**CITY OF CALLAWAY
BOAT RACE ROAD MULTI-USE PATH PROJECT
BID NO.: PW2021-05**

ADDENDUM #1

Date Issued: September 1, 2021

PLAN VIEW
 Sheet No. **9**

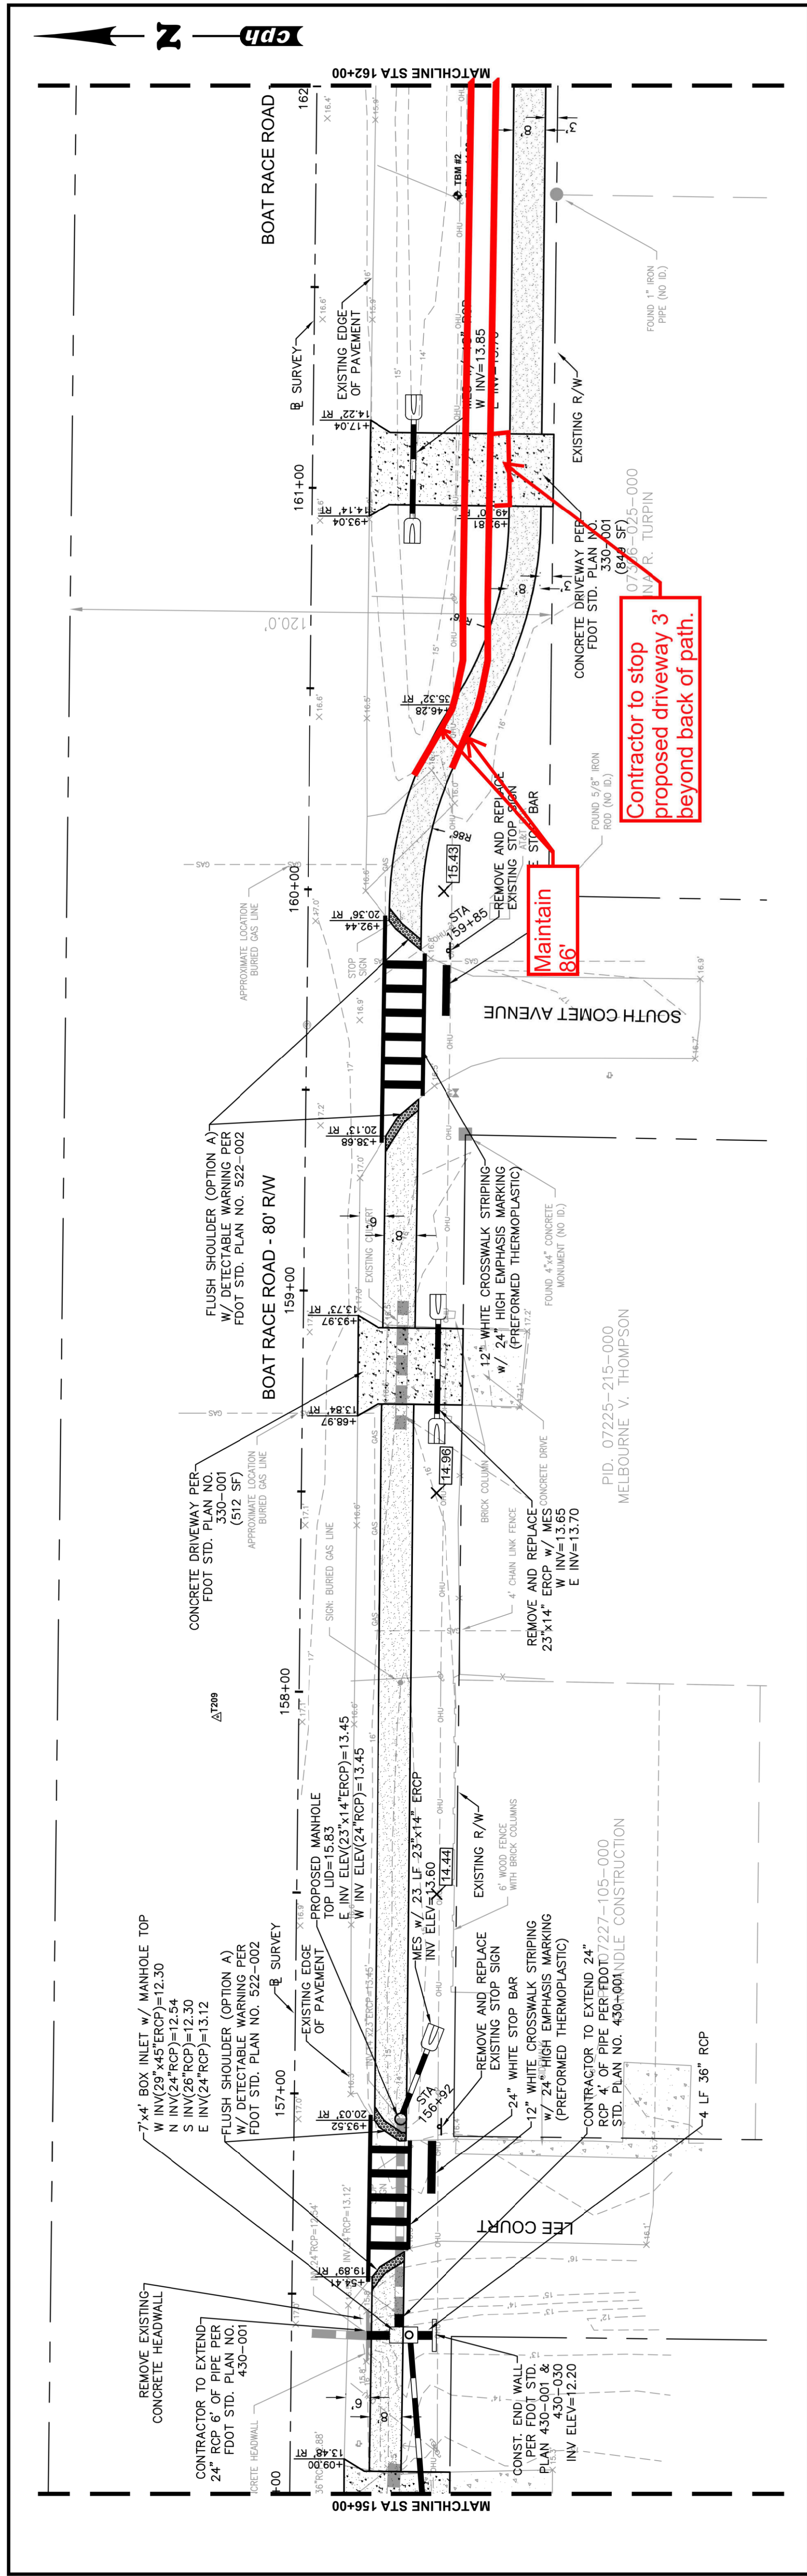
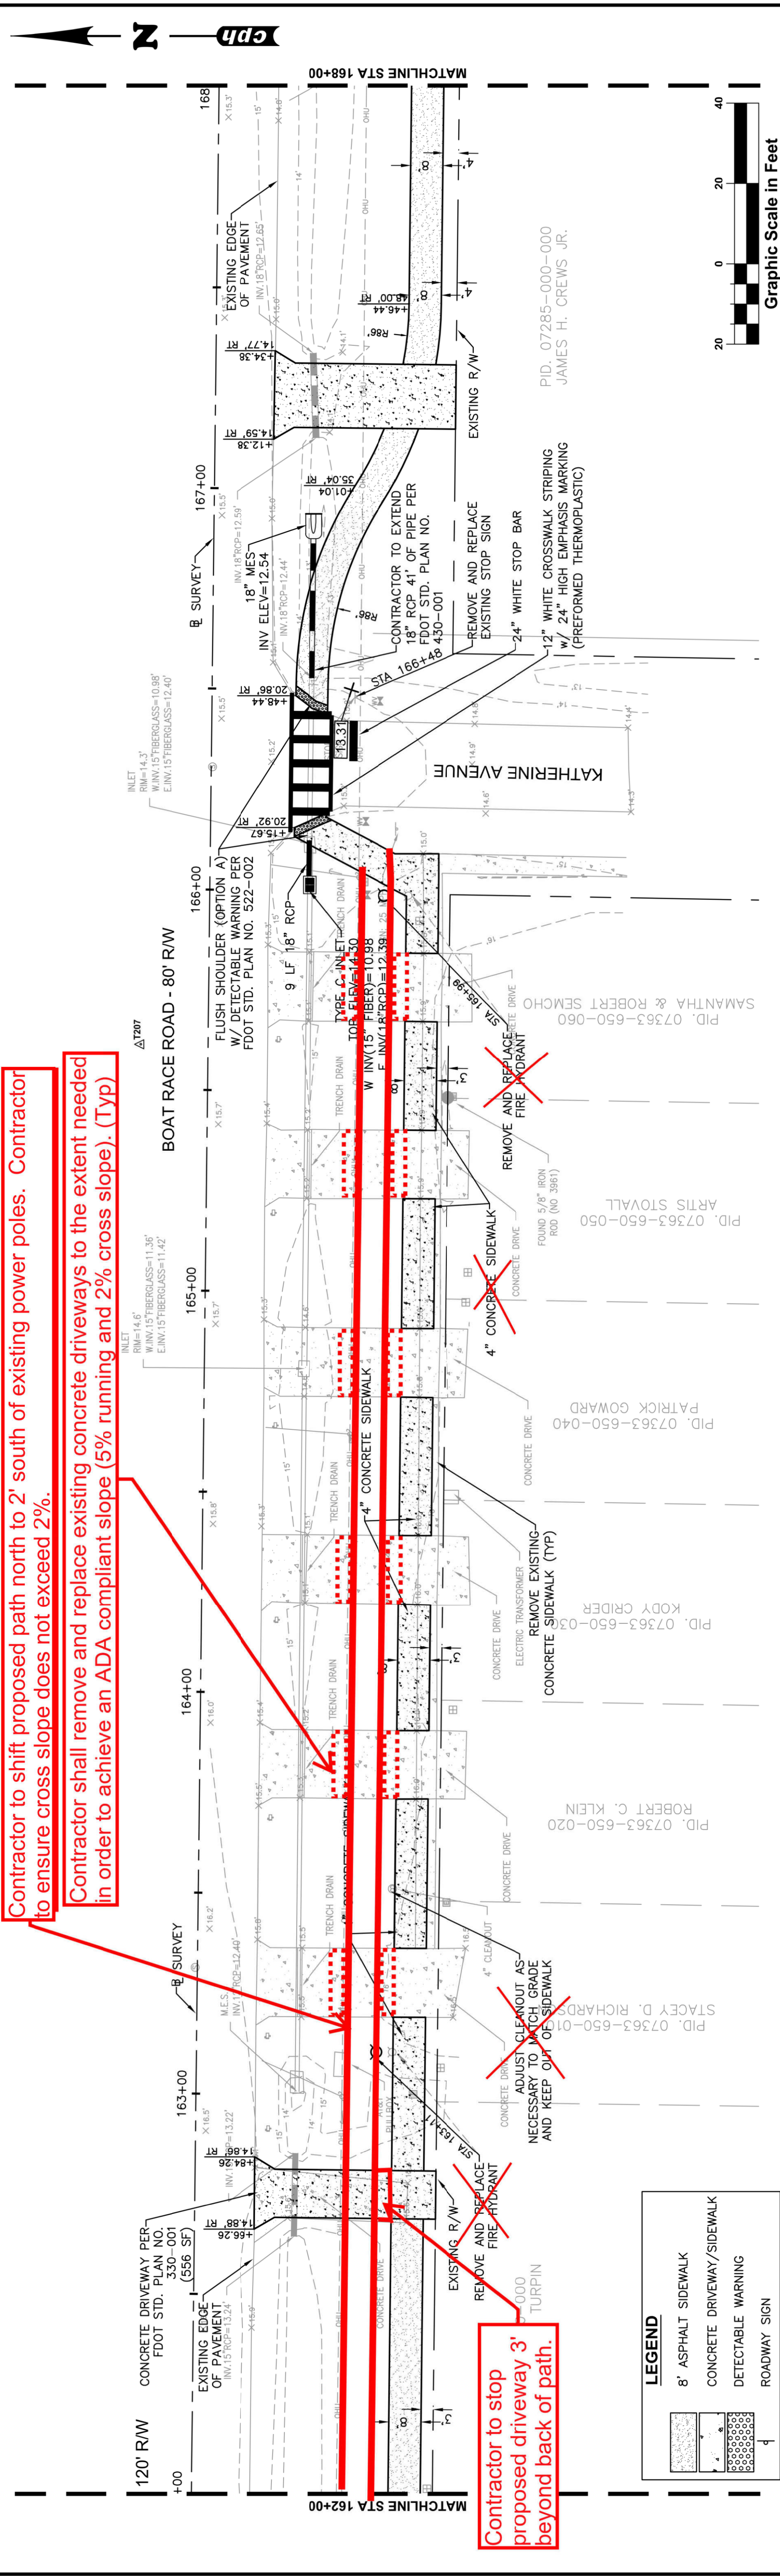
1. A revision to page 9 of the plans, as attached herein. The sidewalk station around 160 to station 166 will shift closer to the roadway in order to pull away from the existing homes.
2. Any Quality Control testing will be the responsibility of the contractor, such as densities and concrete sampling.

Contractor to stop proposed driveway 3' beyond back of path.

Contractor to shift proposed path north to 2' south of existing power poles. Contractor to ensure cross slope does not exceed 2%. Contractor shall remove and replace existing concrete driveways to the extent needed in order to achieve an ADA compliant slope (5% running and 2% cross slope). (Typ)

Contractor to stop proposed driveway 3' beyond back of path.
